OVERALL FLOOR PLANS - BLDGS.; V, W

REDWOOD THE HARRISON PHASE IV

Willowood Left PVC - 1A2.10L - 1A2.11L - A2.12R

PREFAB WILLOWWOOD MODEL

Willowood Left
 (reverse this for a Willowood Right)

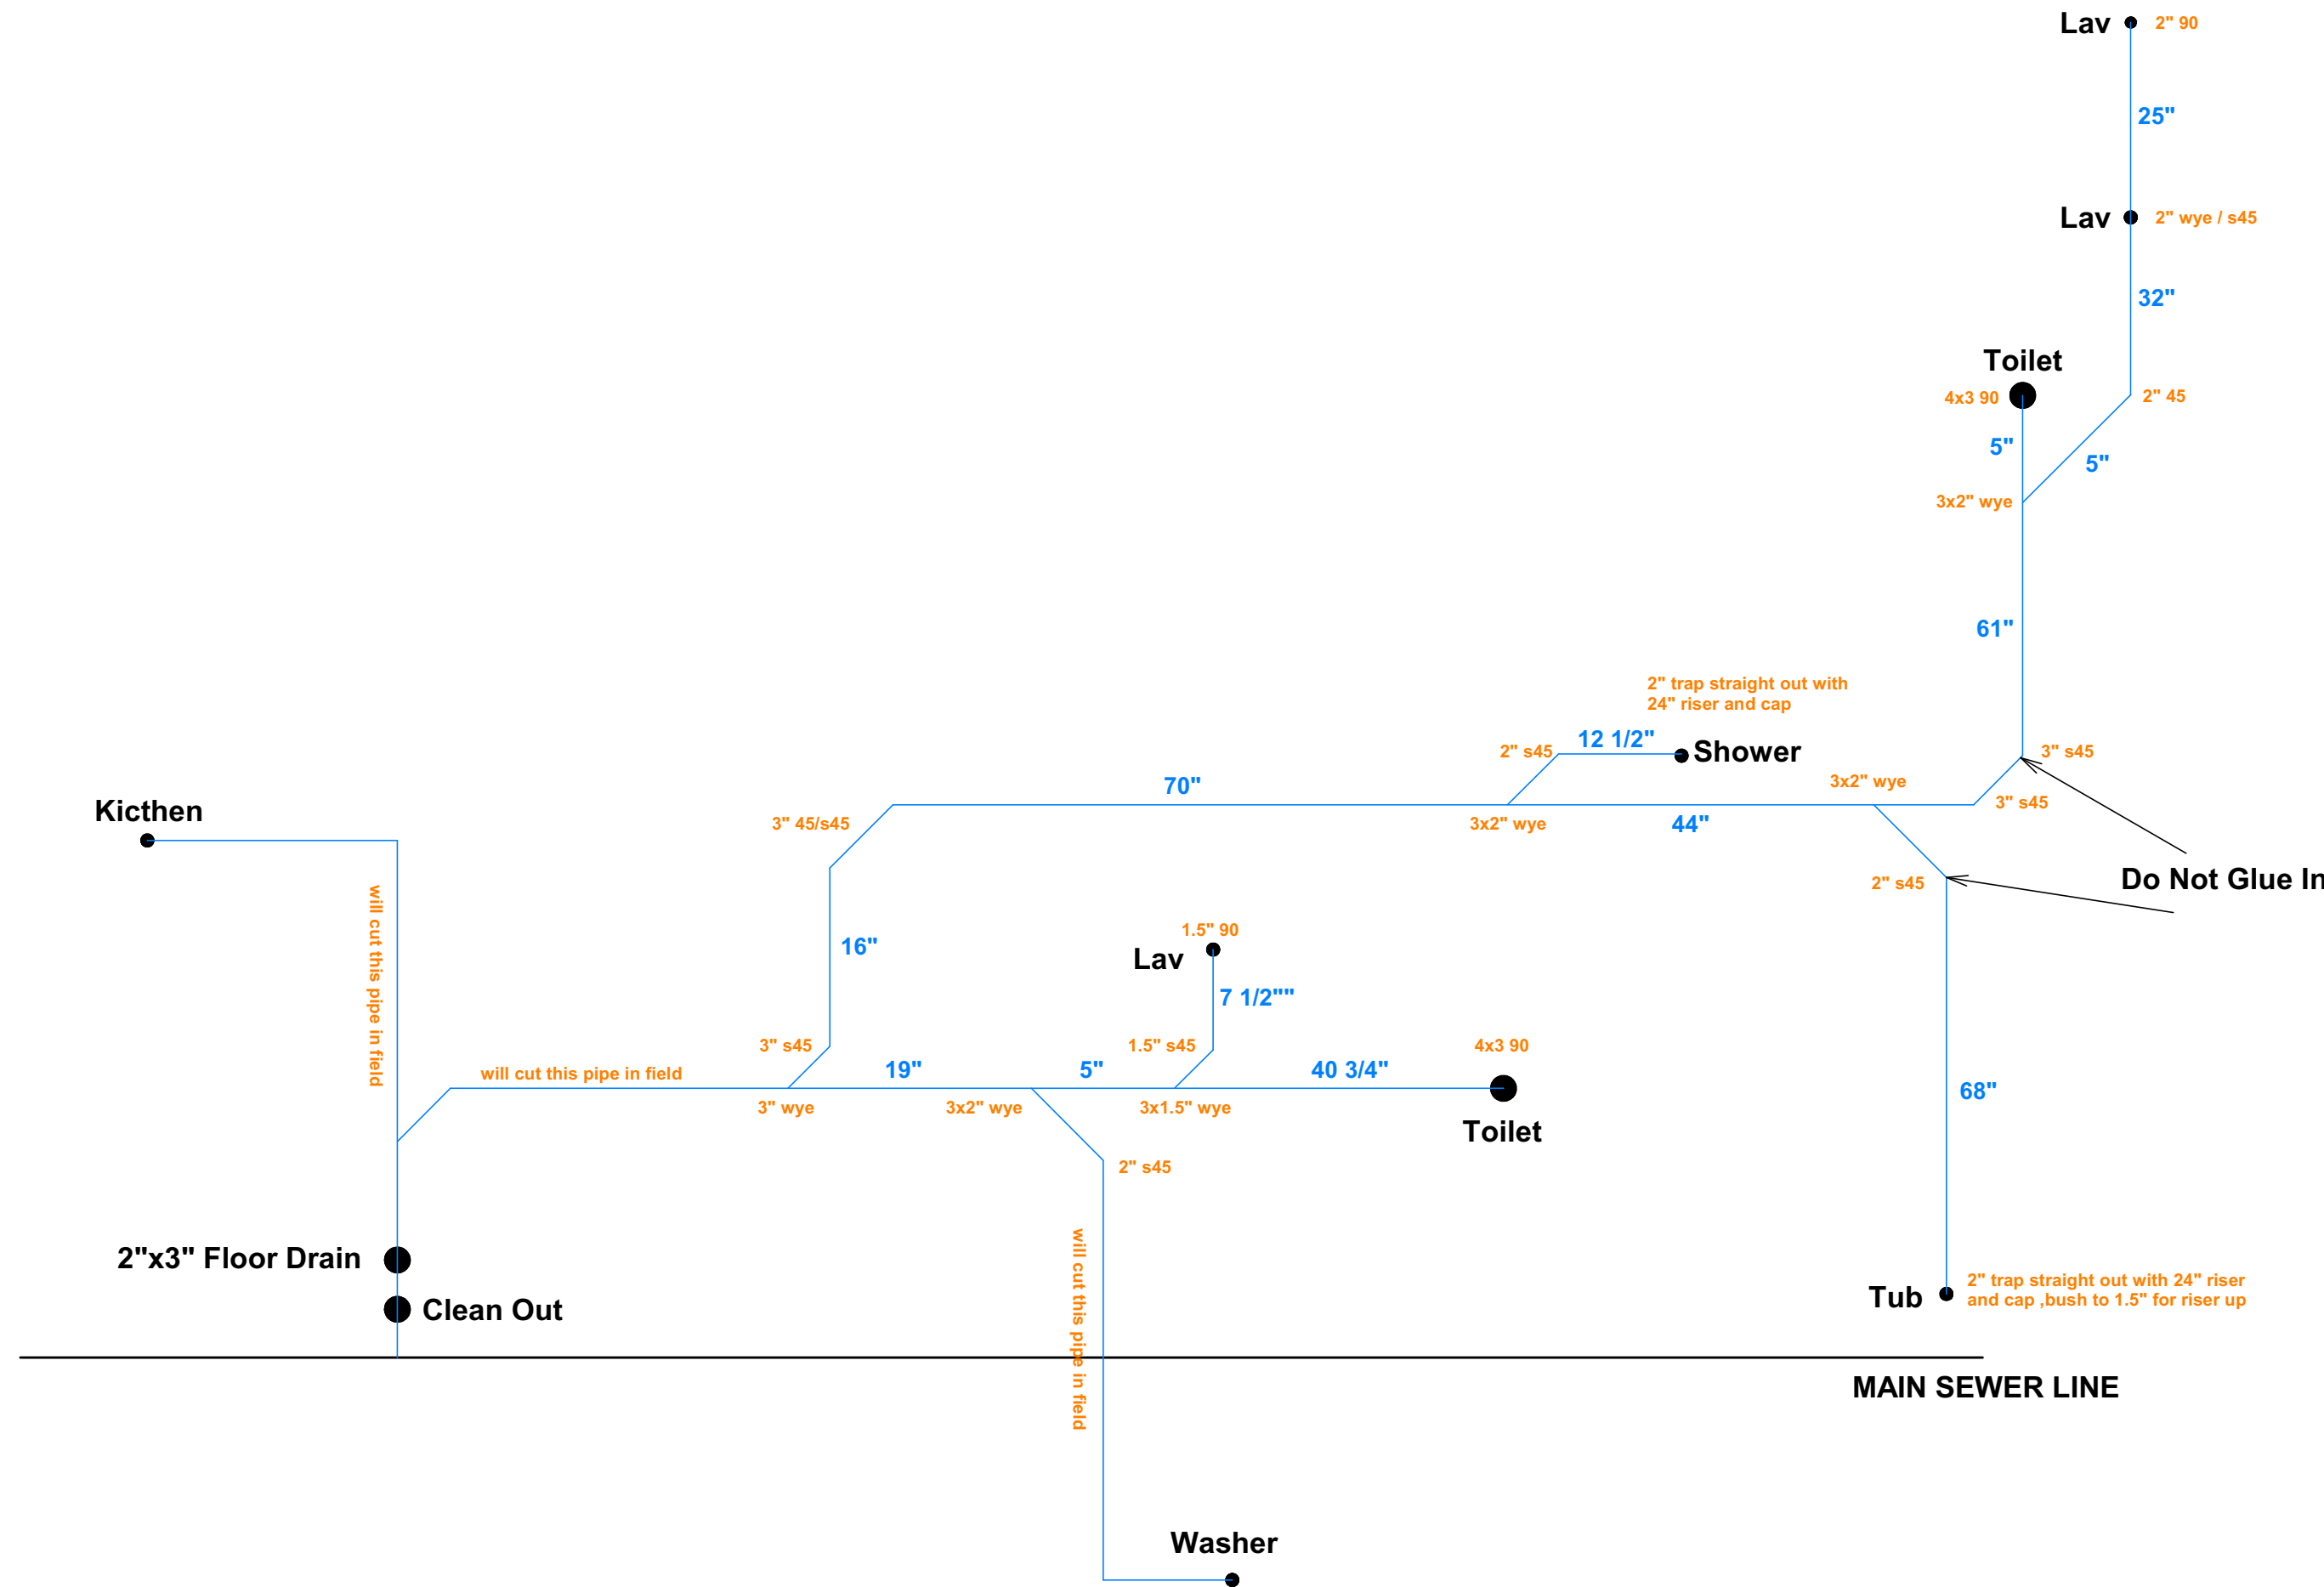
- When doing any traps , trap and trap 90 come straight out , no angles
- Make up 2" 90 and riser w/cap for washer
- Make up 1.5" 90 and riser w/cap for kitchen
- Make up 2" trap and riser w/cap for floor drain
